Series 3700A System Switch/Multimeter

Version 1.56 Firmware Release Notes

PR51964 Models affected:

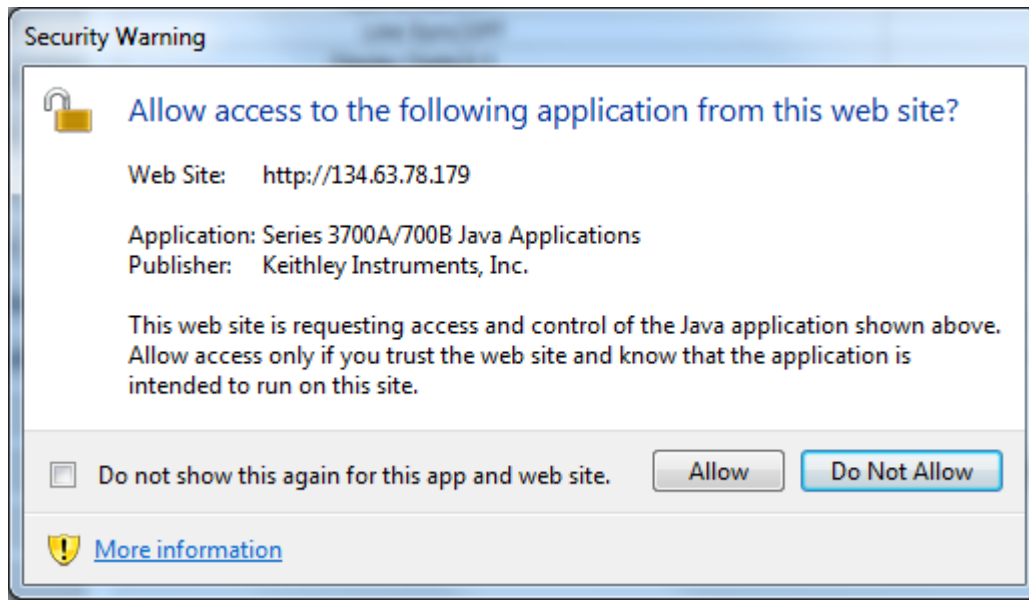
When switching from one web application to another for the first time, a Java security warning window similar to the one shown below is used to get the user's permission. In the most recent versions of Java (7u65 and 8u11), the security warning window appears **behind** the web browser when using Internet Explorer. Until the security warning window is acknowledged, the web browser will appear to be unresponsive. This only happens with Internet Explorer.

Enable the "Do not show this again for this app and web site." check-box prior to clicking the "Allow" button.
